### SERVICE BULLETIN

HN-217.1 DN-158.1 EN-48.1 FN-36.1

**SUBJECT:** INSPECTION AND REWORK OF MAIN AND TAIL ROTOR CONTROL TUBES (PNS 369A7007, 389A7009, 369A7011 AND 369A7012).

**MODELS AFFECTED:** All MD Helicopters, Inc. (MDHI) 369 Series helicopters, including the 369A (OH-6A) Series helicopters.

Figure 1. Control Tube Removal and Boot Rework

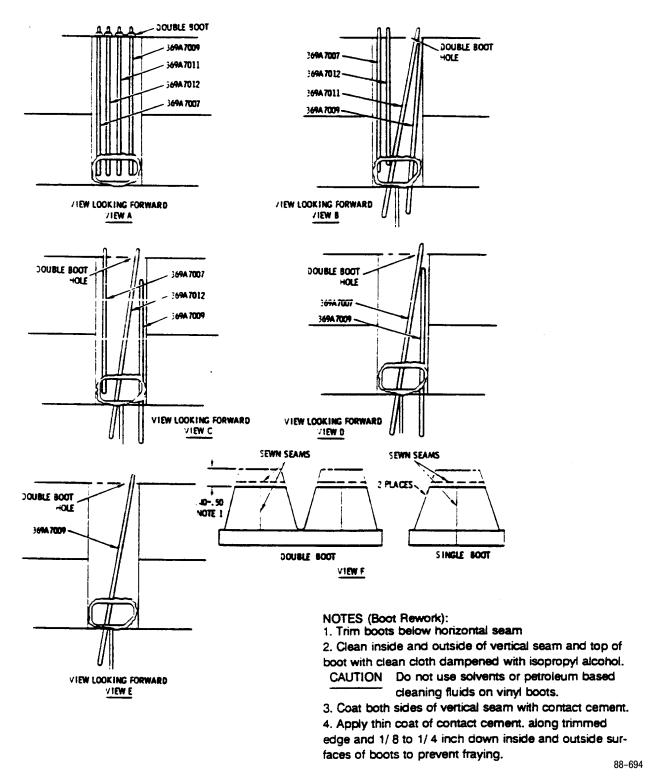
- a. Remove 369A7007, 369A7009, 369A7011 and 369A7012 control tubes as follows: (refer to figure 1)
  - 1. Align blue blade to right side of aircraft.
  - 2. Remove bolts from top of tubes.

- 3. Remove double boot from the 11 and 09 tubes (ref. view A). All tubes will be removed through the double hole.
  - 4 Move blue blade pitch housing down as far as it will go. This will allow the tubes to go past the housing.

- 5. Remove bolts from bottom of 11 and 09 tubes.
  - 6. Move cyclic controls so that the 12 tube moves to its highest point (ref. view B). Place 09 tube to the far right and lower out of the way. Lower 11 tube to the left side of center beam. This will allow 11 tube to angle up through the double hole.

- 7. Remove bolt from bottom of 12 tube and lower to belly of aircraft and angle up through the double hole (ref. view C).
  - 8. Remove bolts from bottom of 07 tube and lower to the belly of aircraft, then angle up through the double hole (ref. view D).

- 9. Move 09 tube to the other side of center beam and angle up through the double hole. To install tubes just reverse sequence (ref. view E).
- b. Using paint stripper (refer to HMI), remove paint approximately six inches back from end of each tube (tapered area of tube).

- s. Rework control tube boots per Figure 1, View F.
- t. Reinstall control tubes and boots in reverse order listed in Part I. Reinstall trimmed boots with vertical seam facing aft. If control tubes have not been accurately measured, flight controls will require rerigging.
- u. Check flight controls for interference or binding.
- v. Record compliance to this Service Information Notice in the Compliance Record section of the helicopter Log Book.

Figure 2. Sleeve Fabrication and Installation

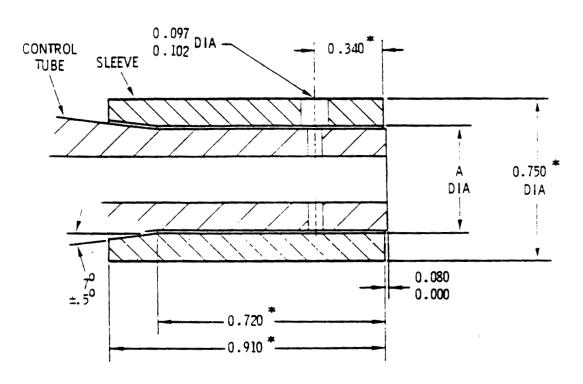
- d. Measure outside diameter of control tube end and select sleeve per table in figure 2.
- e. Temporarily install sleeve onto control tubes per figure 2. Align sleeve and control tube witness hole. If sleeve protrudes past end of control tube, trim end of sleeve flush (0.000 inch) or back (0.080 inch) from end of tube.
- f. Thoroughly clean end of control tube and interior surfaces of sleeve with lint free cloth and MEK, or equivalent.
- g. Mix epoxy adnesive per manufacturer's instructions.
- h. Plug end of control tube to prevent adhesive from entering threads.

i. Bond sleeve to control tube per figure 2. Apply adhesive to both surfaces and install sleeve. Align witness/rivet hole in sleeve and tube.

- m. Install rod ends into end from which it was removed.
- n. On fixed rod end, align witness/rivet hole in sleeve and tube with rivet hole in rod end. Drill (#40) thru opposite end of sleeve.
- o. Rivet fixed end with MS20470AD3-15 rivet.
- p. Adjust each control tube to its previously measured length.
- q. Paint control tube ends with primer. Paint adjustable end of control tube flat black.
